SERVICE INFORMATION LETTER
Contains Useful Information Pertaining To Your Aircraft Engine

SIL 04-9

SUBJECT: IO240B13B Manifold Valve Replacement, Heat Isolation Modifications and Throttle Body Modification.

PURPOSE: To reduce heat on the engine fuel system components and enhance idle stability

FIGURE 1

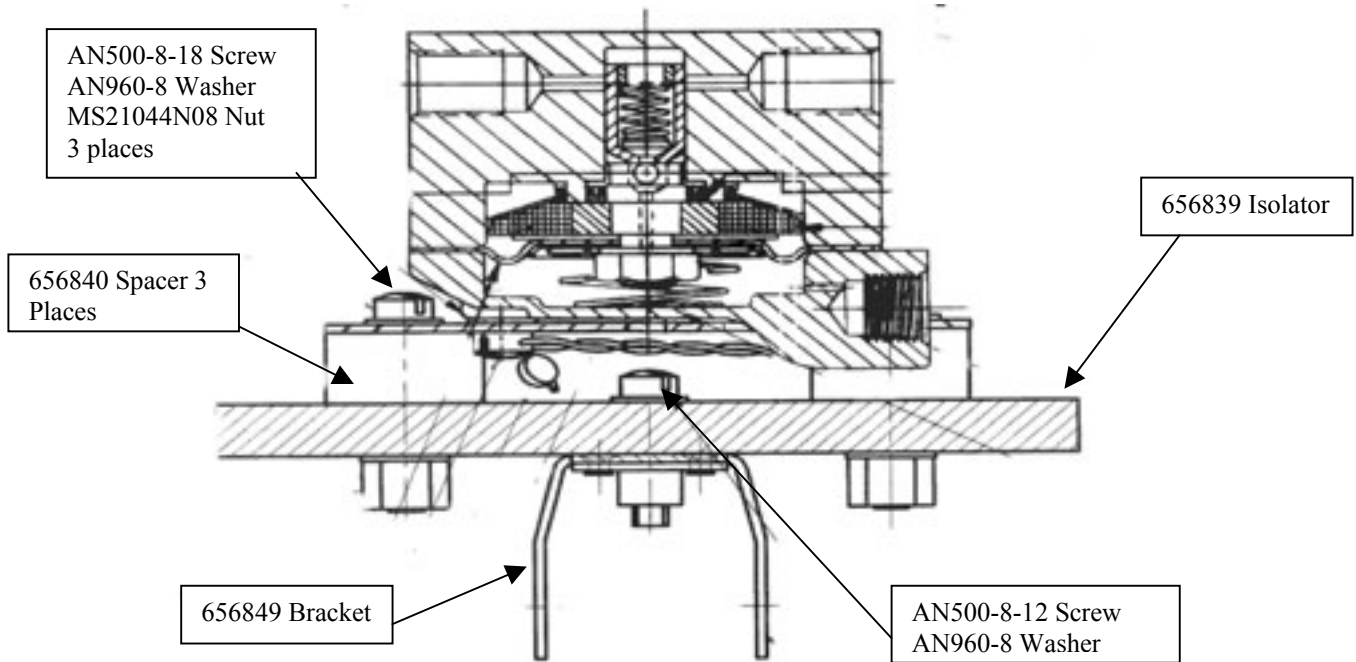
- (9) Install the new 656839 isolator assembly to the 656849 bracket assembly using 2 each P/N AN500-8-12 screws and AN960-8 washers. Torque the screws to 17.5 – 22.5 In-Lbs.

- (10) Install the new 656832-1A1 manifold valve assembly to the isolator plate using 3 each 656840 spacers, AN500-8-18 screw, AN960-8 washers and MS21044N08 self locking nuts. Torque the nuts to 17.5 – 22.5 In-Lbs.

FIGURE 2
INDUCTION SYSTEM ON IOF-240-B3B, B9B & B13B SERIES ENGINES

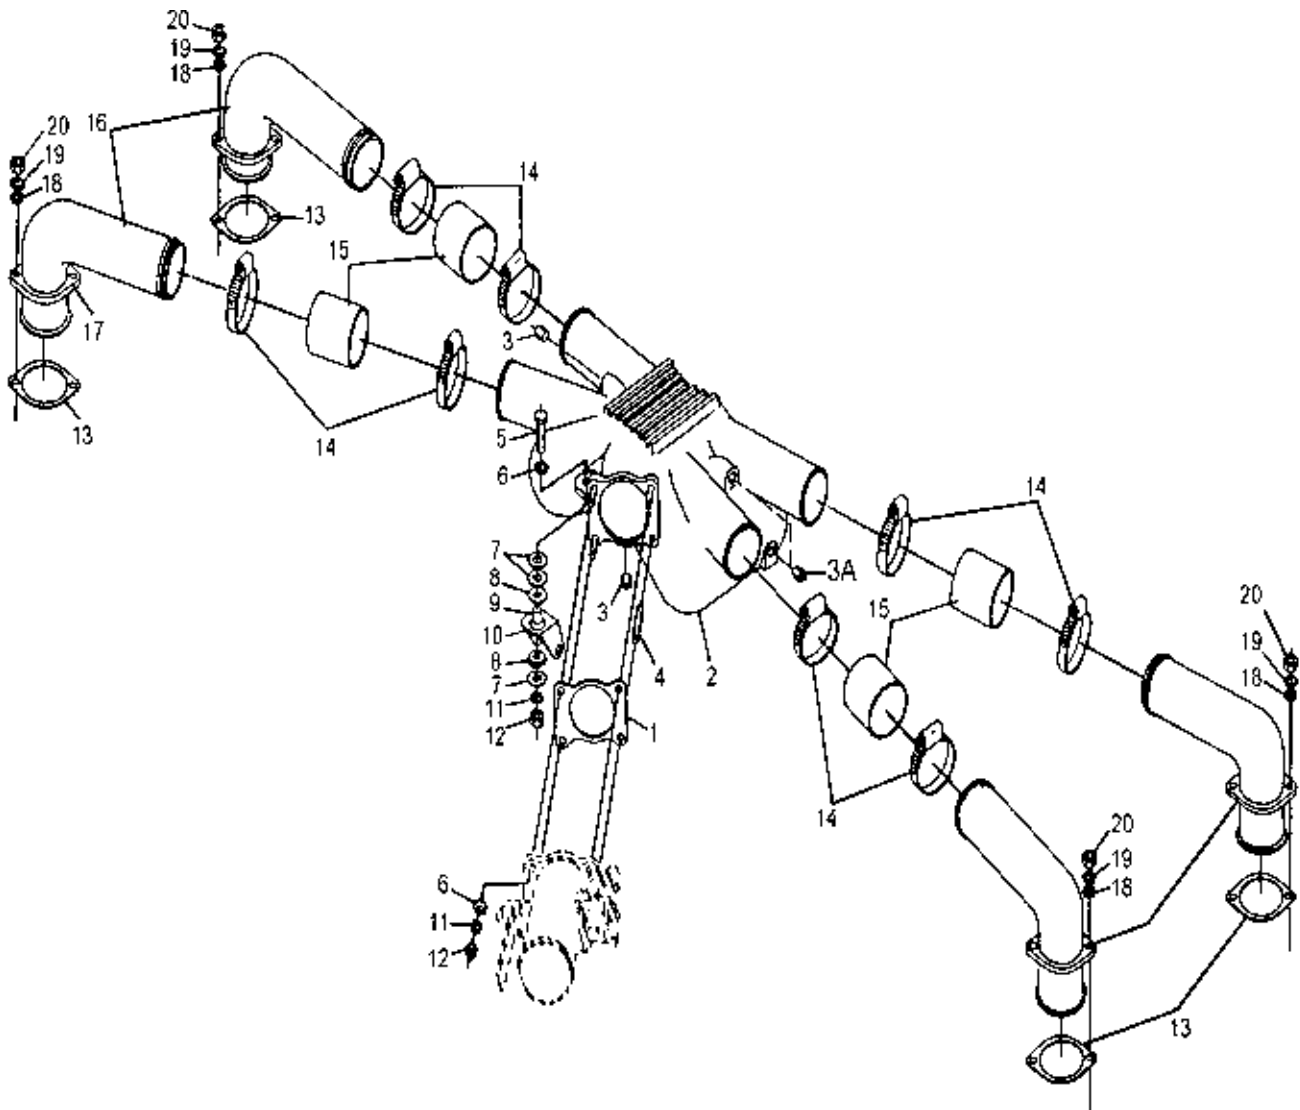
- (a) Remove electrical power from the aircraft.
 - (b) Remove the upper engine cowling from the aircraft.
 - (c) Shut off the fuel supply from the engine by closing the fuel shutoff valve.
- (2) Remove the Throttle and Control Unit using the instructions contained in the latest revision of the IO240-Series Overhaul Manual X30622. Retain the removed hardware for re-installation, discard the gasket. (Reference Figure 1)
- (3) Support the Throttle and Control Assembly with the flange on a suitable flat work surface.

FIGURE 3
THROTTLE PLATE MODIFICATION

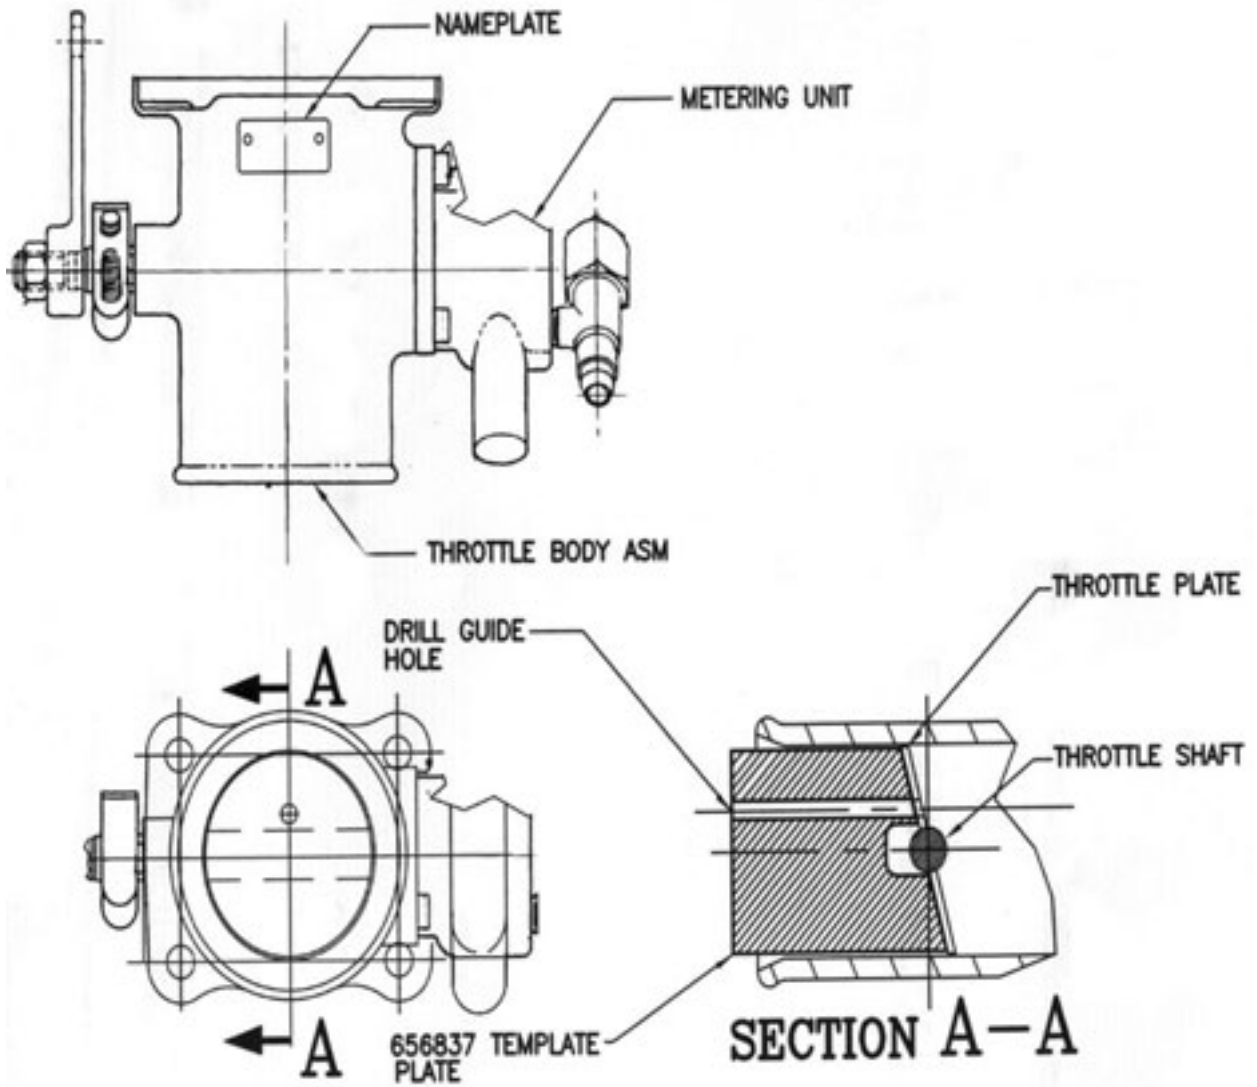
- (4) With the throttle lever in the closed position, insert the P/N 656837 drill guide template into the induction end of the Throttle and Control Assembly, matching the angle of the template to the angle of the throttle plate. (Reference Figure 2)

- (5) Use drill guide hole as shown in Figure 2 to drill through the throttle plate using the P/N 656742 twist drill. A slight downward pressure on the drill template will keep the template properly seated against the throttle plate during the drilling operation. After the drilling procedure is completed remove all burrs, metal shavings and contaminants.
